# ARCHITECTURAL REVIEW BOARD

NOTICE OF PUBLIC MEETING  
copley, oh

## REQUEST SUMMARY

# JACOBY ROAD RESIDENTIAL CONSERVATION DEVELOPMENT

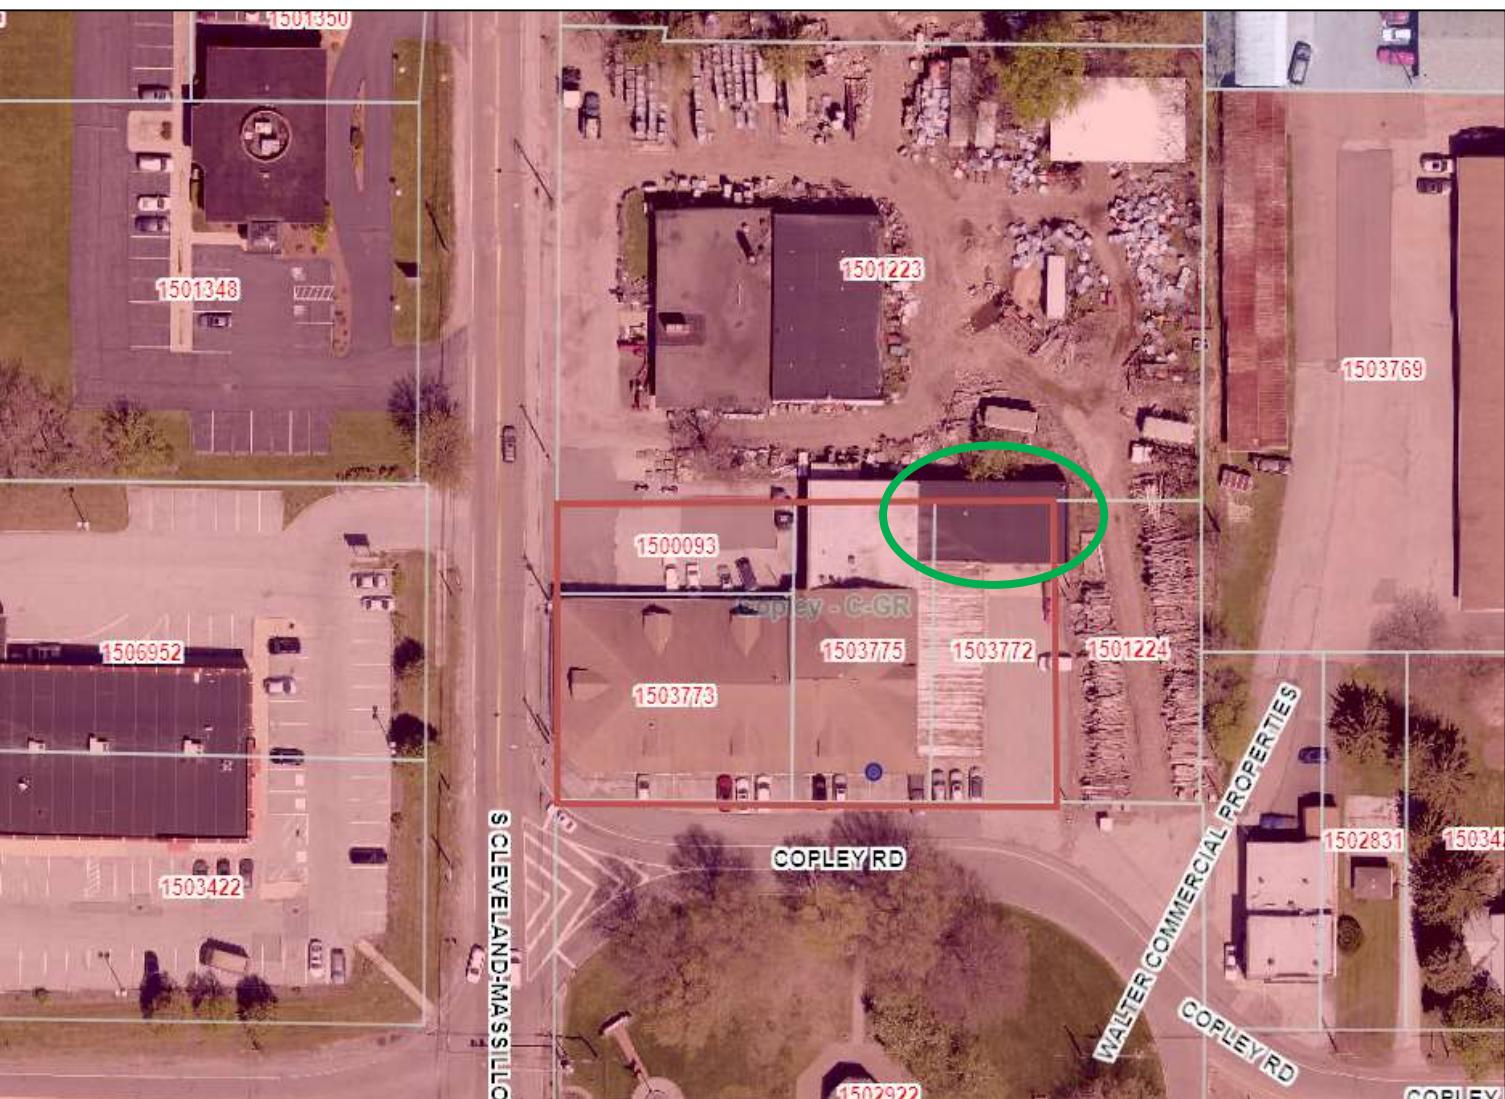
The ground sign was placed previous to review. The sign is post and panel comprised of two individual PVC panels mounted onto the existing frame poles. The sign is externally illuminated with ground lights. The sign is 90" x 48" (30 square feet) in overall area and 6 feet in overall height

**RECOMMEND:** Per 8.07 D., 2, applicant to add street address numerals to sign not exceed 3" in height. The numerals can be added to the bottom of the sign, similar to the design below.

The applicant has a second changeable copy ground sign. There are no permits or approvals on record for this sign. Therefore, the sign is illegal, non-conforming and must be removed to bring the property into compliance. Applicant may apply for a temporary changeable copy sign permit.

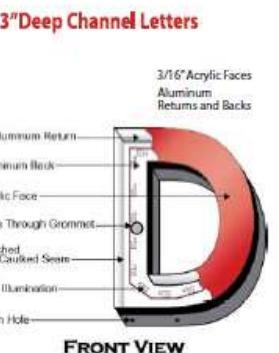
On 11/18/2020, the Board of Zoning Appeals approved a modification to the variance granted to the existing Business Center Sign. The variance was approved for the addition of 4 sign panels, not to exceed 36 square feet in overall area.

The applicant is requesting a sign panel which is approximately 9 square feet in overall area.

WETLAND A  
(0.261 AC IMPACT  
(0' SETBACK REQUESTED  
& 35' SETBACK PER CODE)

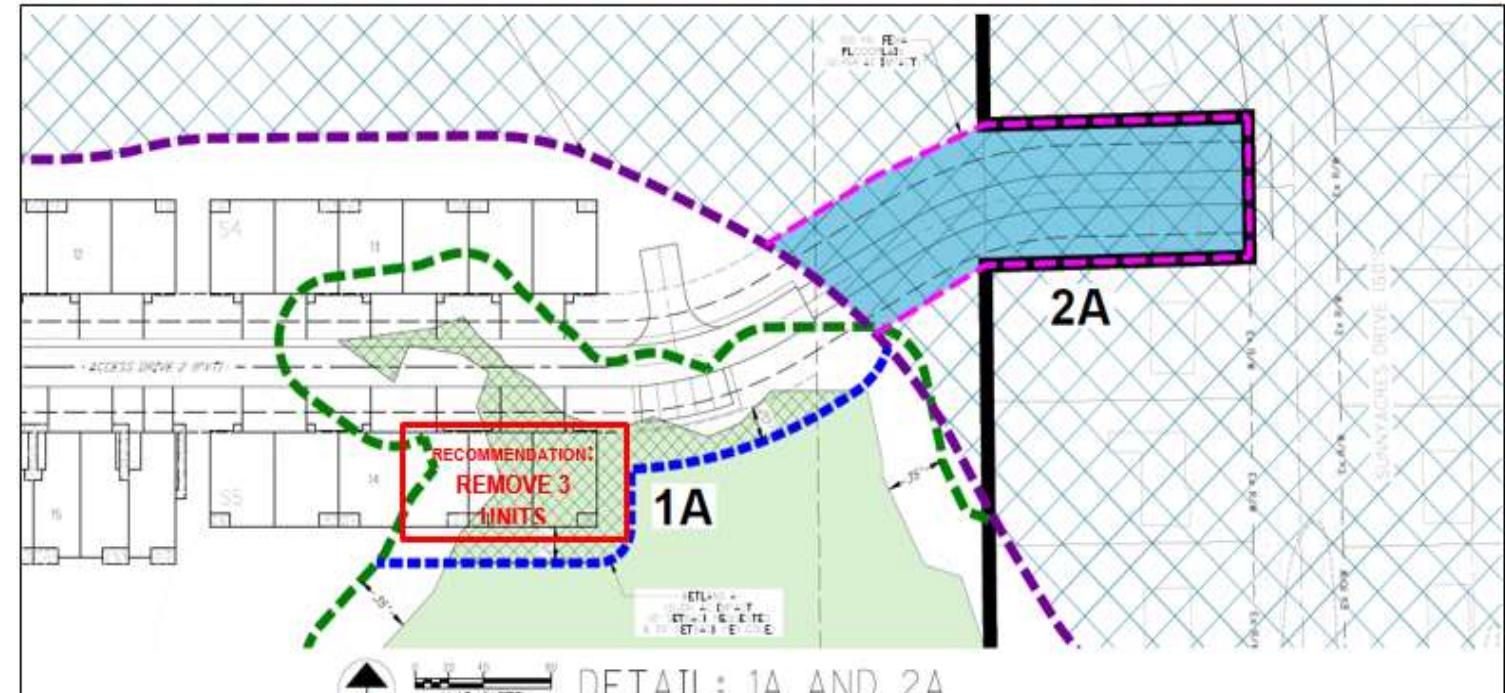
1 A (WETLAND A): The applicant is seeking approval to remove 0.261 acre of wetland for the construction of 3 units and installation of roadway and a 0' from the identified wetland.

2 A (WETLAND A): The applicant is seeking approval to remove an existing home and construct a roadway for secondary ingress/egress inside of an identified floodplain.

**STAFF RECOMMENDATION:** Eliminate identified units to avoid wetland removal and maintain a wetland setback.

**SUMMIT SOIL & WATER CONSERVATION DISTRICT:** No objection.

**STAFF RECOMMENDATION:** Approval. Secondary ingress/egress is required for Fire/Safety measures. There is an existing impervious structure (home) which will be removed and replaced with a roadway.

**SUMMIT SOIL & WATER CONSERVATION DISTRICT:** No objection.

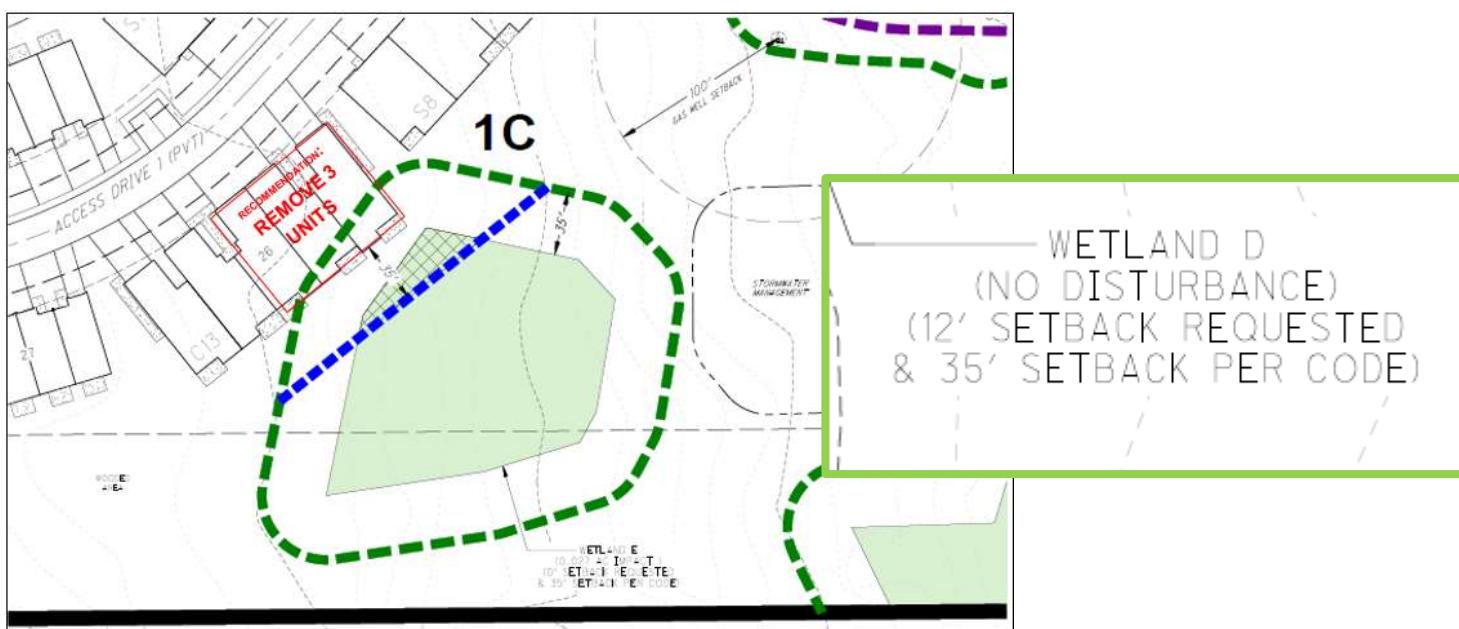
IB (WETLAND E): Applicant is seeking relief from the required 35' wetland setback. There are no proposed impacts to the wetland area. The applicant is seeking approval to maintain a 12' setback from the wetland.

IC: (WETLAND D) Applicant is seeking relief from the required 35' wetland setback. The applicant is seeking approval to maintain a 0' setback from the wetland. Applicant is seeking approval to remove 0.027 acre of identified wetland.

**STAFF RECOMMENDATION:** Approval.

**SUMMIT SOIL & WATER CONSERVATION DISTRICT:** No objection.

**STAFF RECOMMENDATION:** Eliminate identified units to avoid wetland removal and maintain a wetland setback.

**SUMMIT SOIL & WATER CONSERVATION DISTRICT:** No objection.

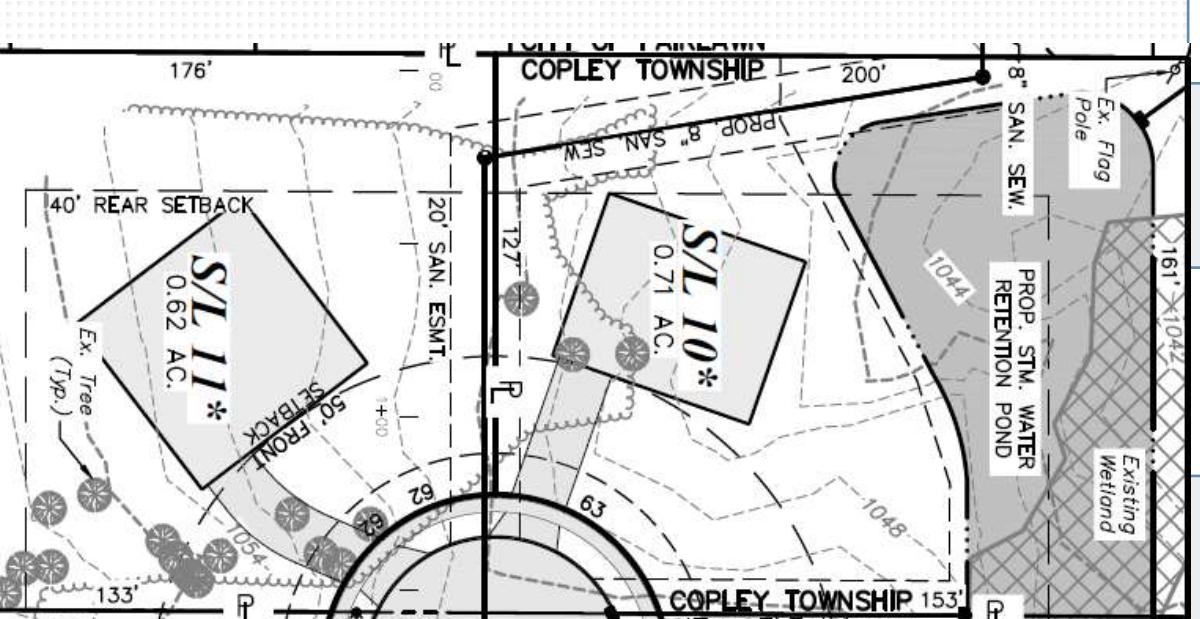
One immediate concern is that the response to the three homes in Copley could be delayed due to the closing of Rothrock Road. Fairlawn officers responding to that development would most likely travel there via Rothrock Road (and would have access before the delineators) or through Rosemont Blvd. Copley officers could come from those areas, as well. However, since of our officers spend a significant amount of time in Montrose, our response to an emergency in that area would often be quicker via Rothrock Road, only after traveling through the delineators, or via Rosemont after activating the gate. The gate would delay our response slightly because the gate must first be radio activated, which sometimes takes a couple tries, and then the officer would have to wait for the gate to rise. Responding through the delineators can cause damage to police cars as well.
